# Aesthetic Assessment and Recommendations for the Proposed VELCO Lamoille County Project Transmission Line and Substation Upgrades

Docket No. 7032, VELCO Lamoille County Project

Submitted to:  
State of Vermont  
Department of Public Service  
Montpelier, VT

Submitted by:  
LandWorks  
Middlebury, VT

**Near  
Mile 0.0**

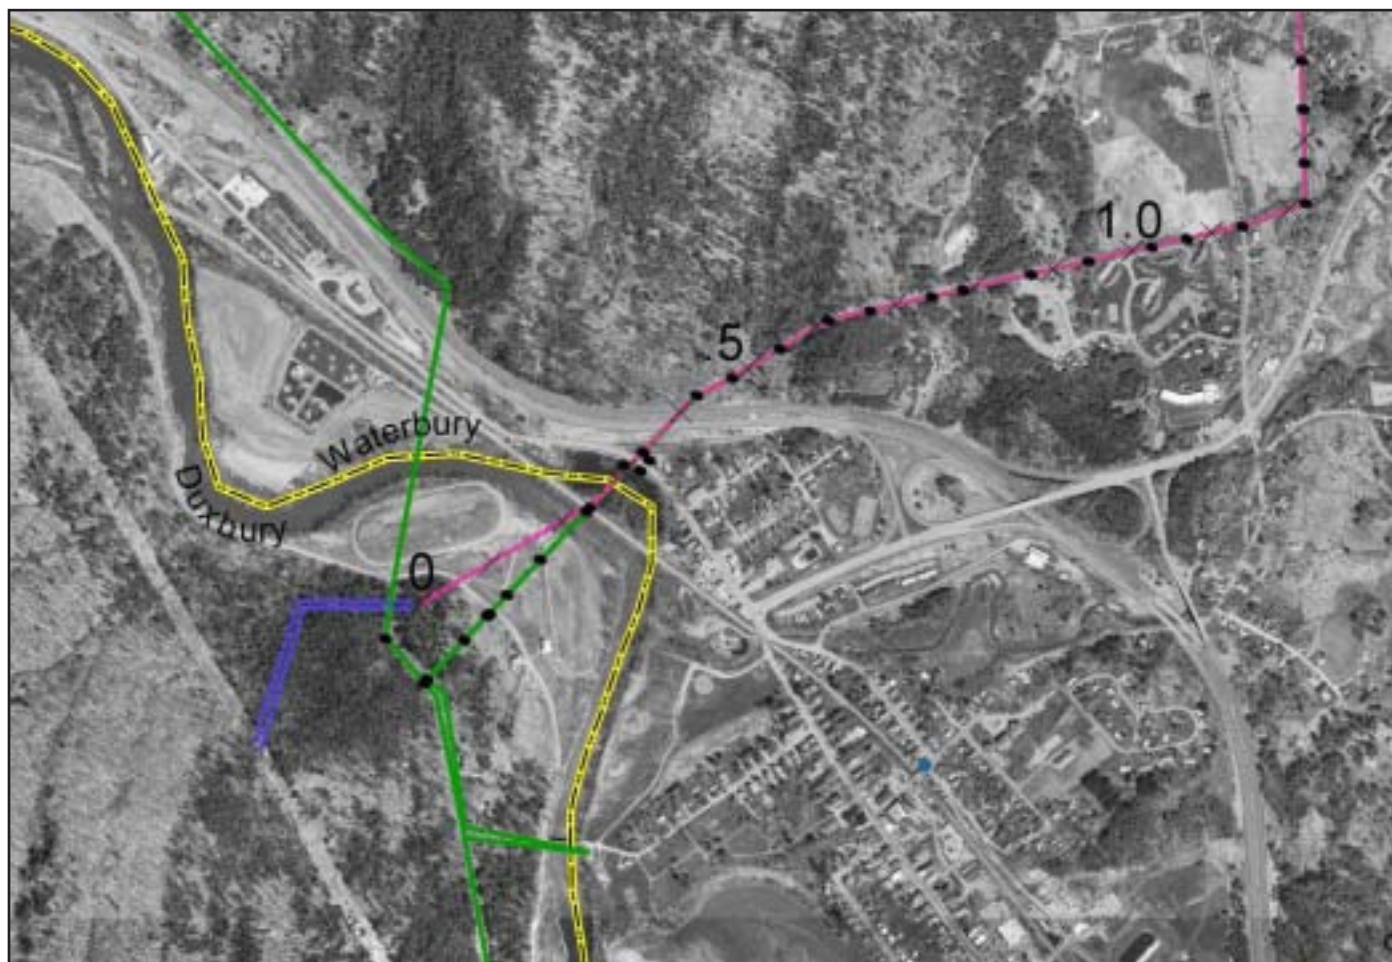
View south at existing crossing on River Rd. An aesthetic improvement will be gained with the removal of the existing GMP line, but the new cut and proposed H-frames will add a significant new impact here.

**Approx.  
Mile 0.0  
- 0.1**

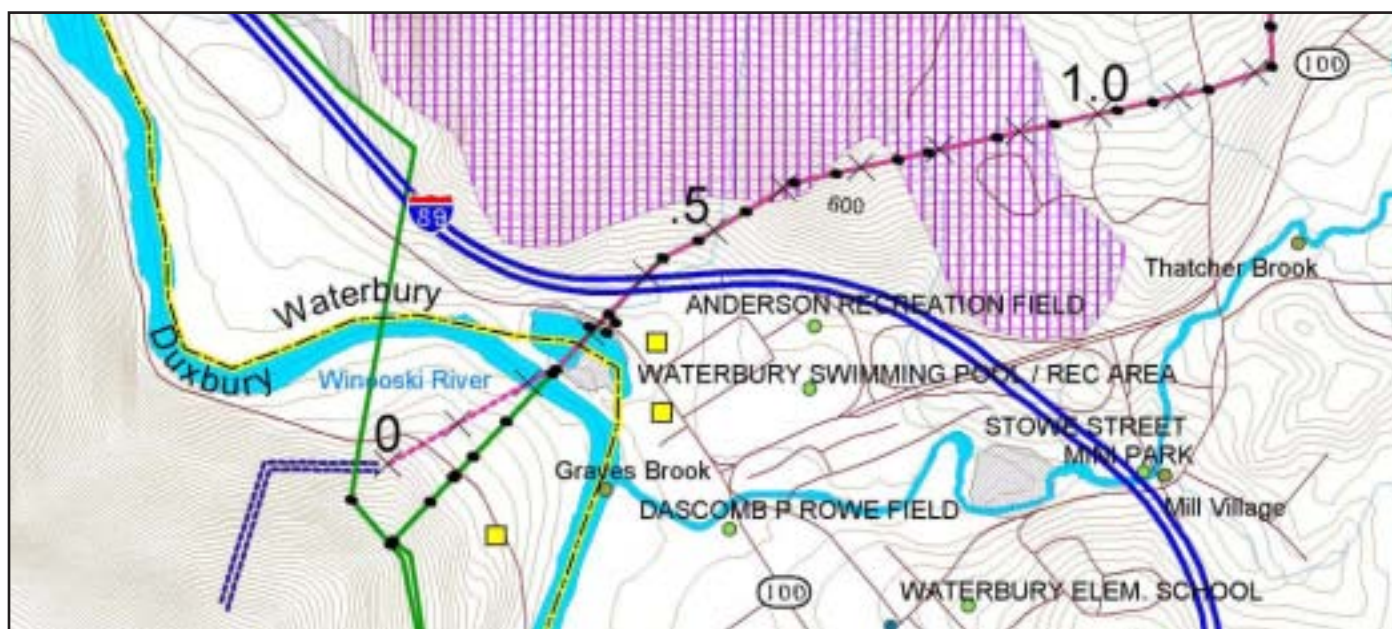
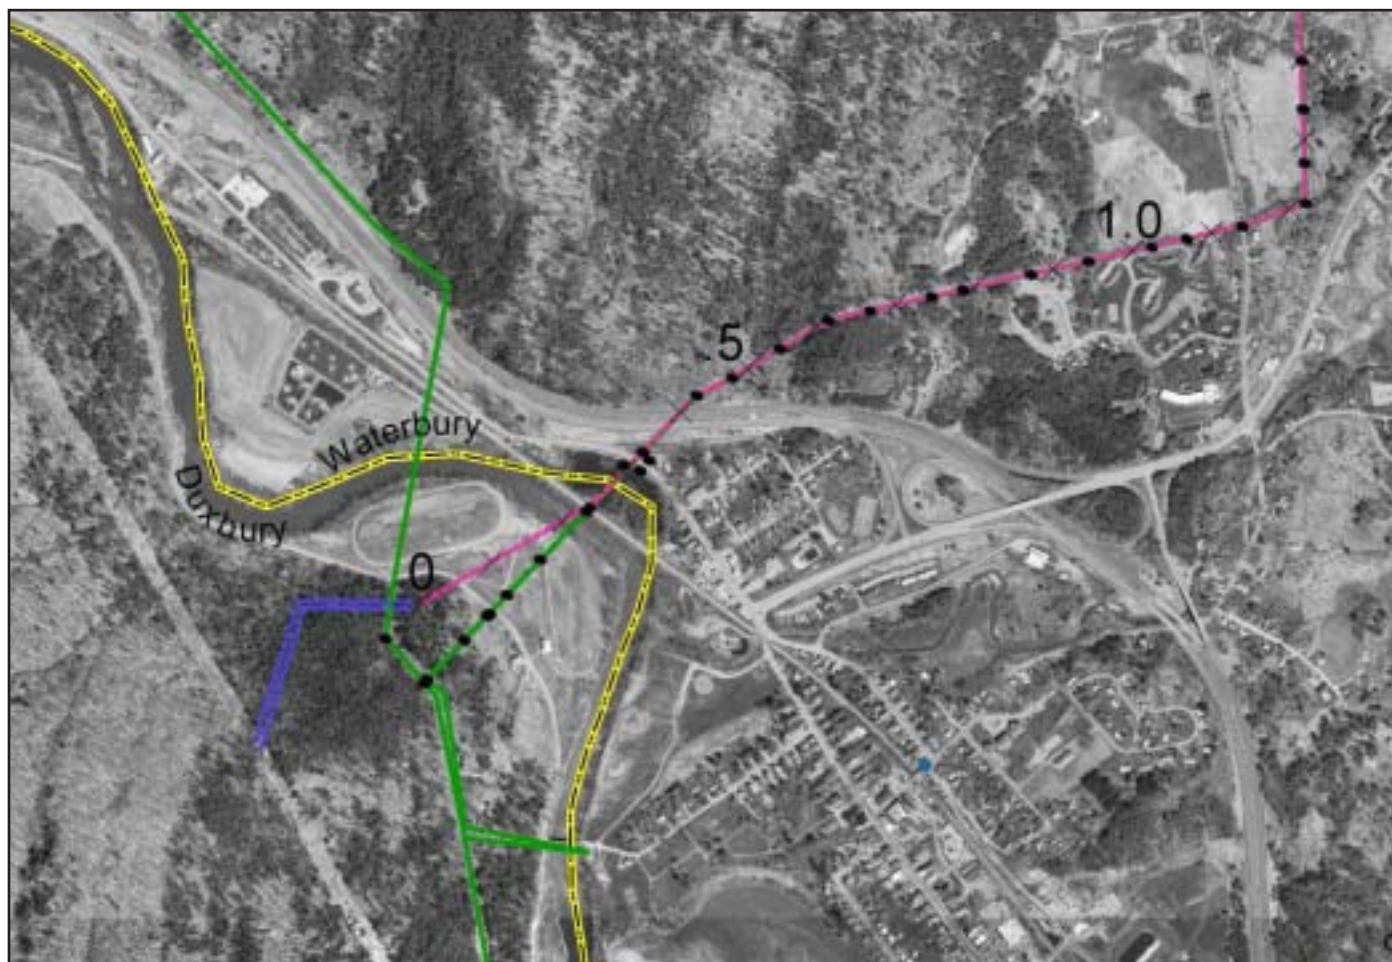
Wooded slope of Crosset Hill where existing vegetation will be cleared for new corridor. The potential exists for the removals to result in extensive new openings with loss of trees beyond R.O.W.

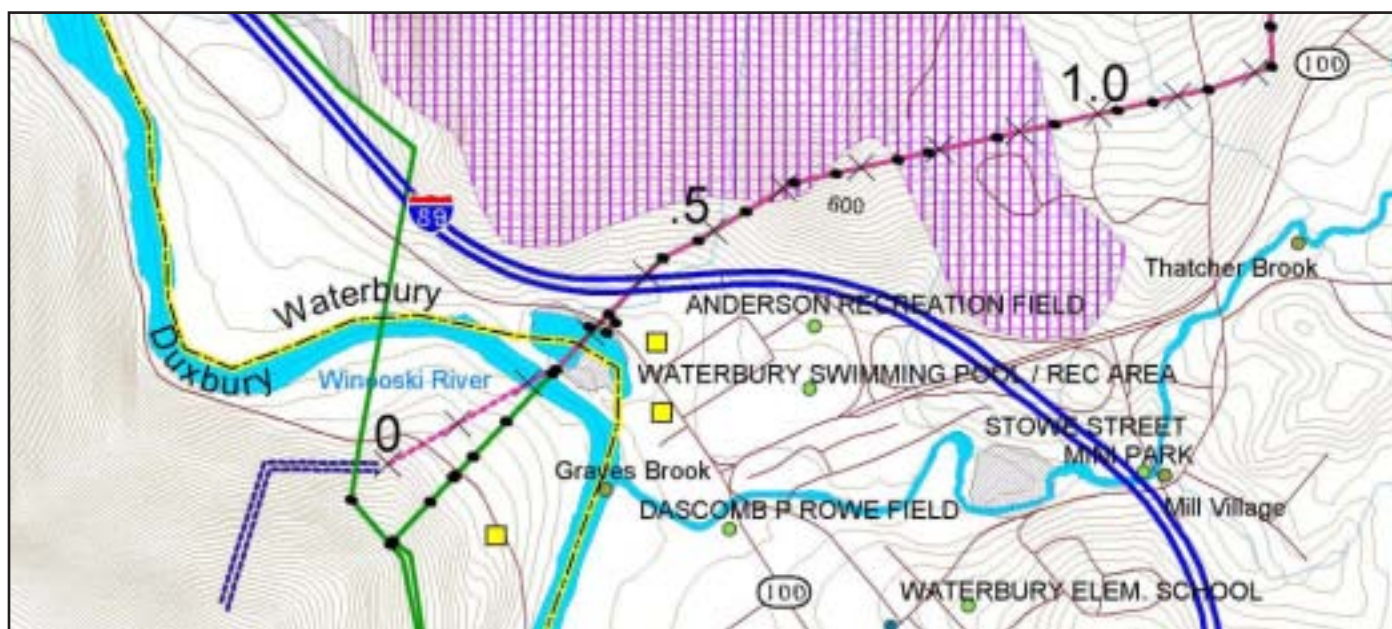
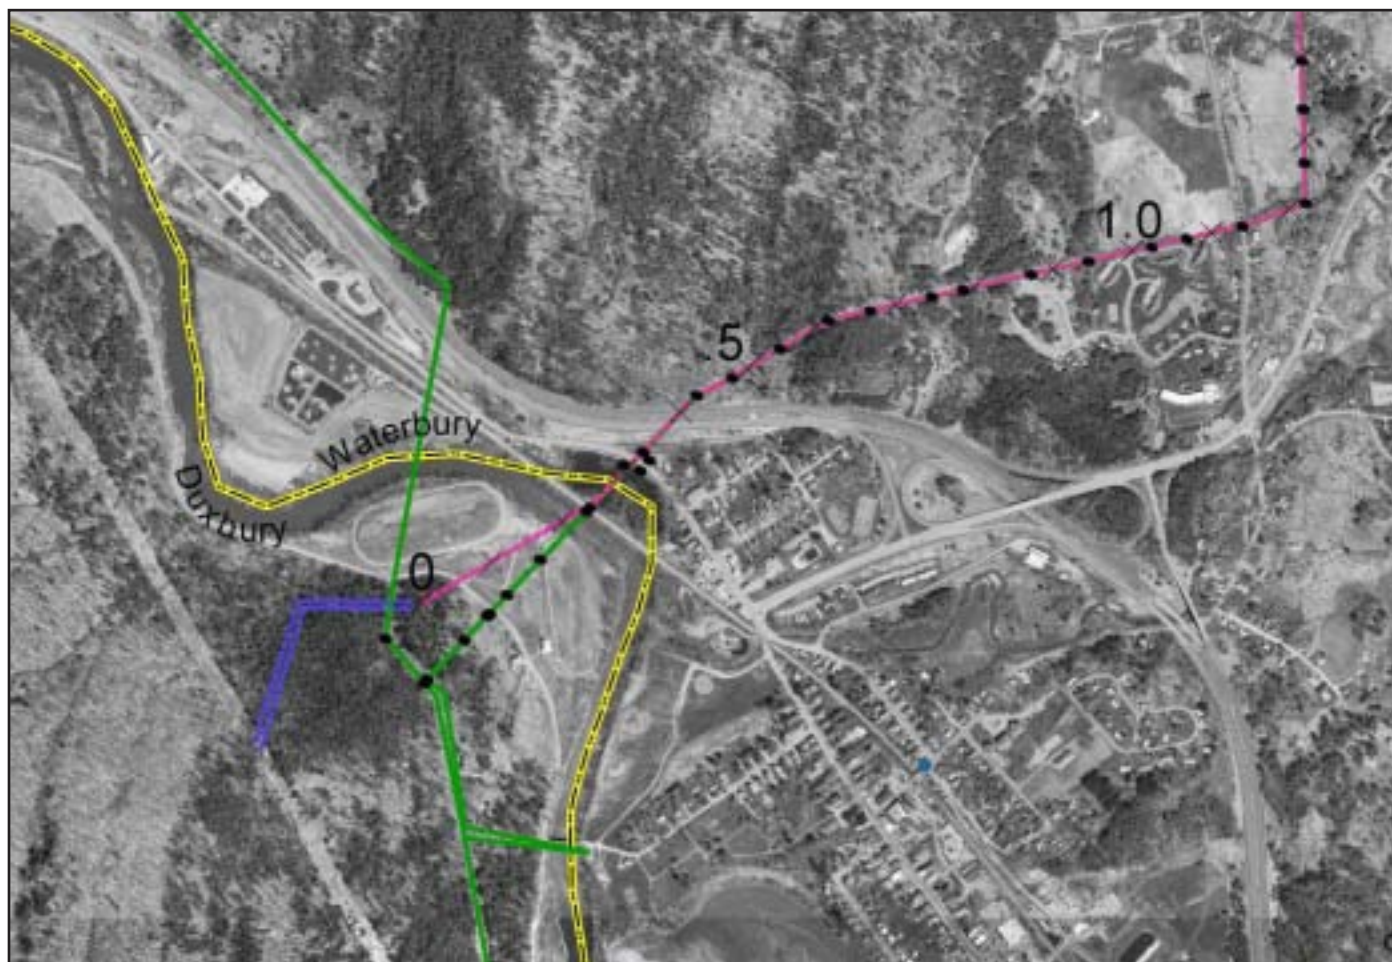
View from River Rd. looking up Crosset Hill parallel to new cut. With the loss of trees there is concern that the new corridor will be very visible. There is not substantial screening there today.

Parallel to new corridor. Replanting of evergreens (hemlocks) at corridor edge is critical, along with vegetative management and planting outside of the right of way will be necessary.

Heading east on River Rd. The cut on the south side of Blush Hill is highly visible, and will widen with the new construction. New street tree plantings here and on North Main Street may be desirable to de-emphasize views.

**Approx.  
Mile 0.3**

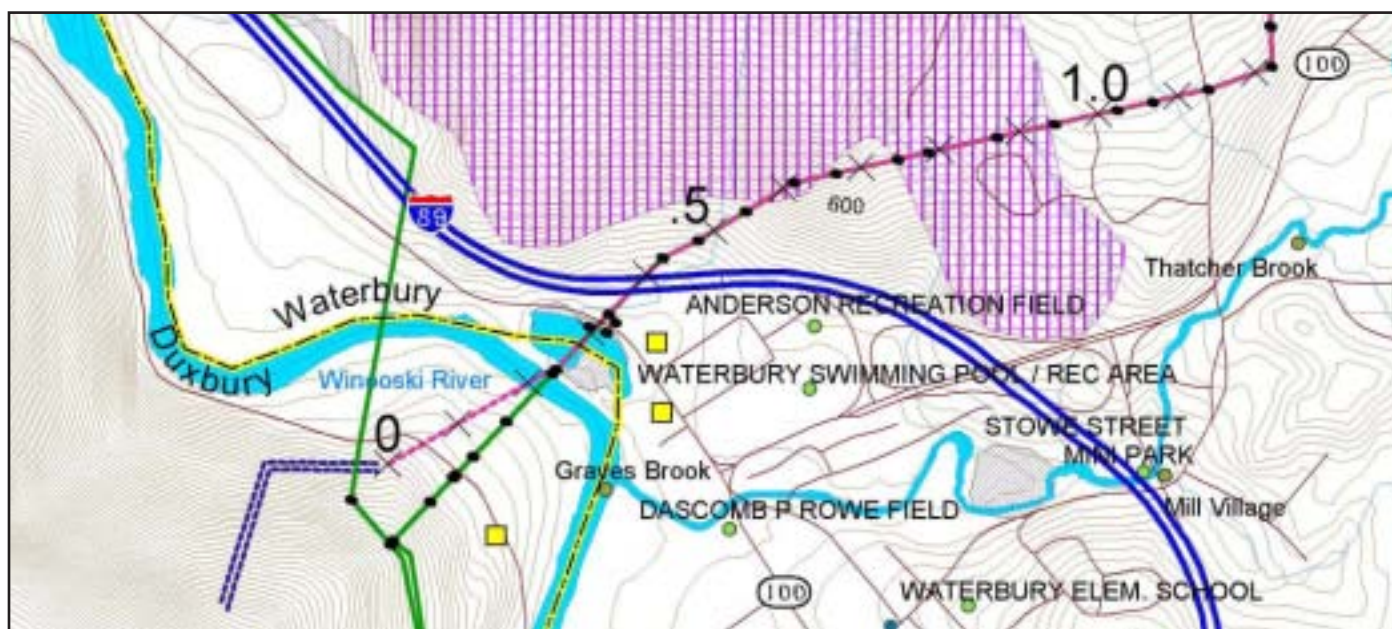
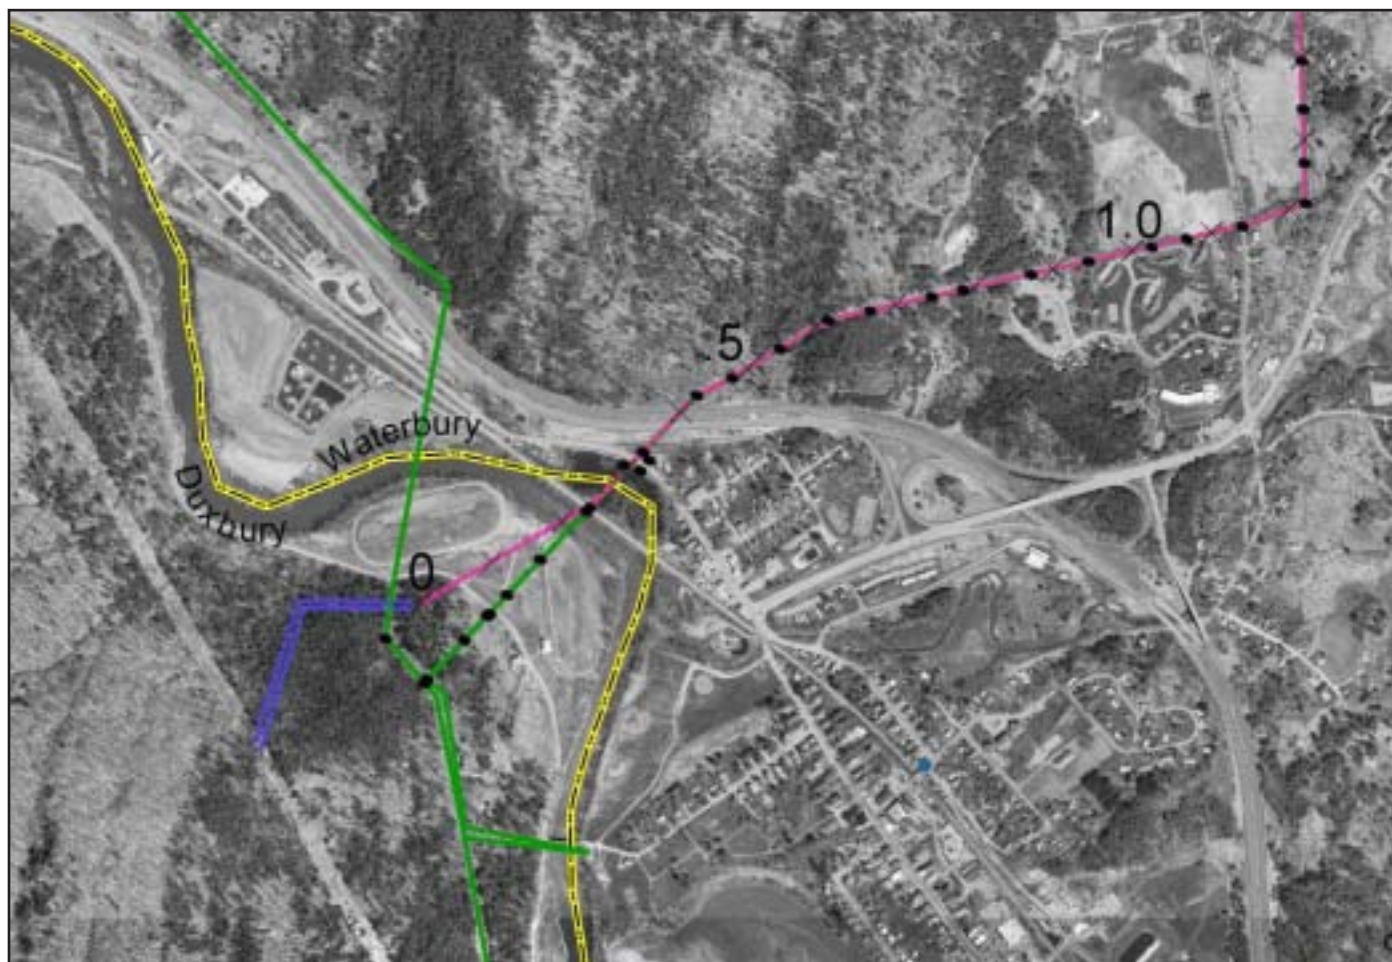
View looking north from Interstate 89 (southbound). A wider cut may result in a box cut. New structures may reach above treeline.

### Mile 1.2

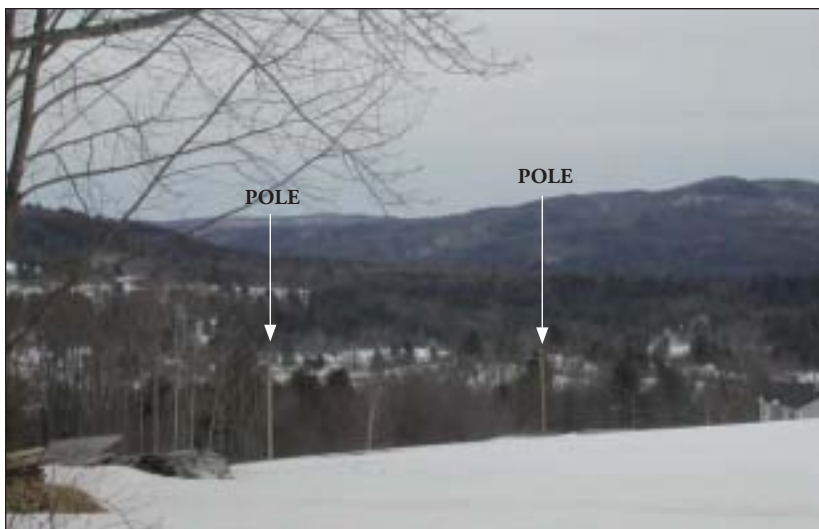
View east from Blush Hill Rd. Pole is skylining with the Worcester Range as the backdrop. Obstruction of views and skylining is a concern here.

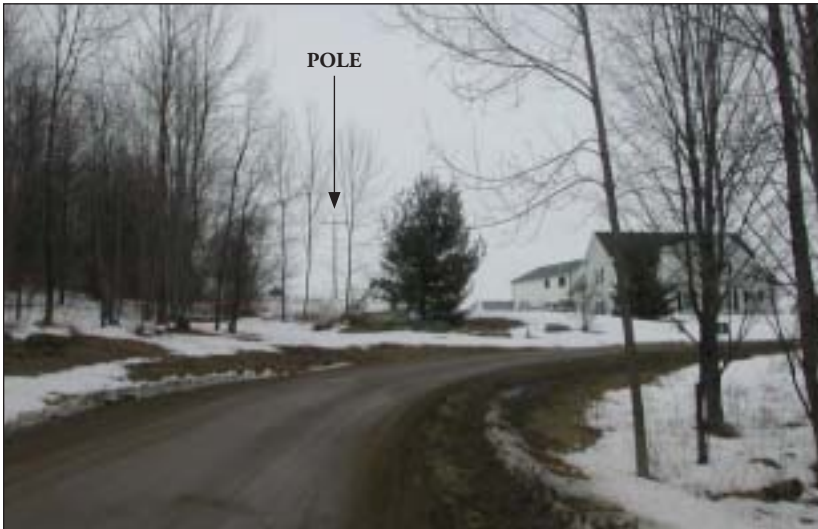
**Mile 1.4 - 1.5** View north at Meadow Crest. Line is assimilated into existing trees which must remain.

**Mile 1.4 - 1.5** View from Meadow Crest up corridor. More screening for road and around home will be necessary.

**Approx.  
Mile 2.3**

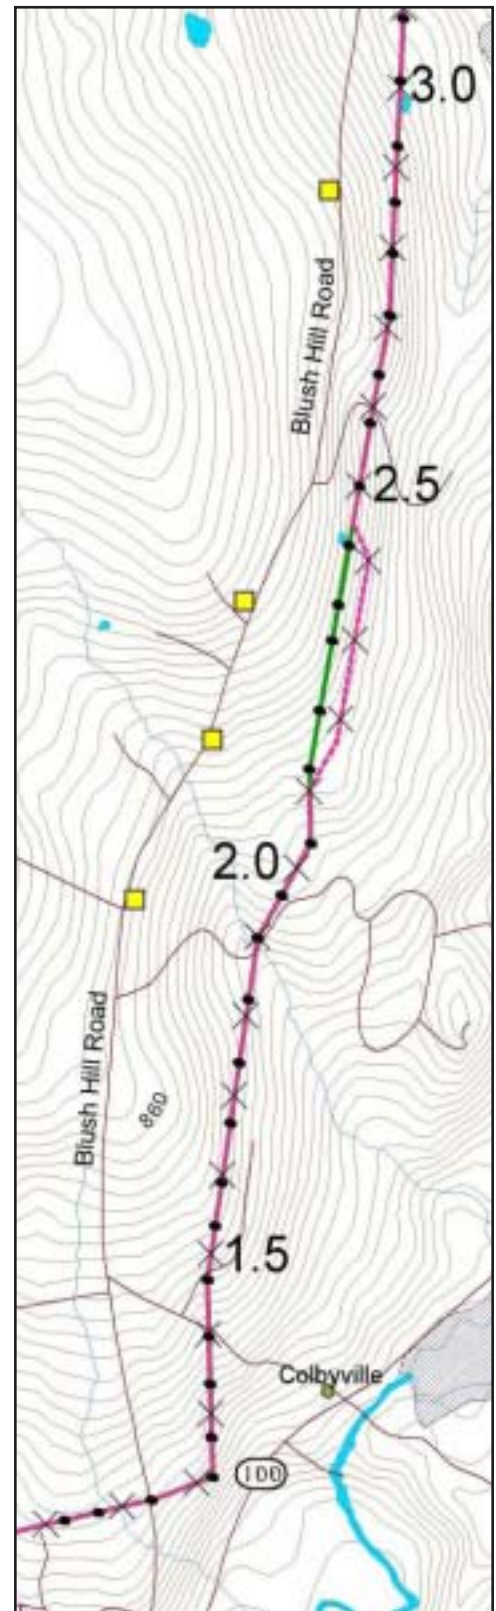
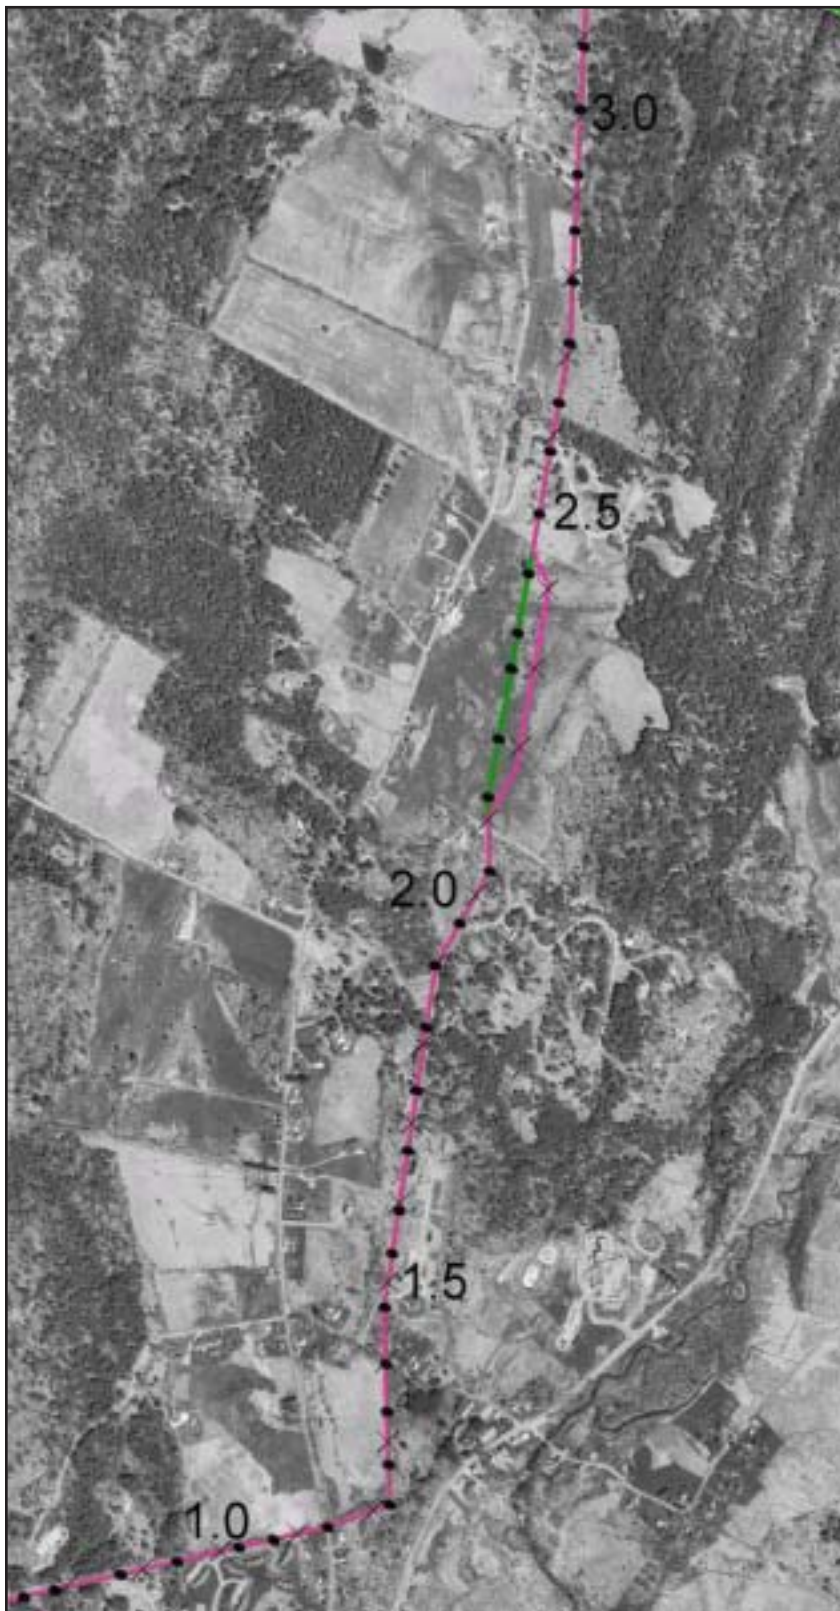
Historic former dairy farm silo  
with existing line in the open  
field / pasture. An alternative  
rerouting to what VELCO pro-  
posed is recommended here to  
avoid an undue adverse impact.
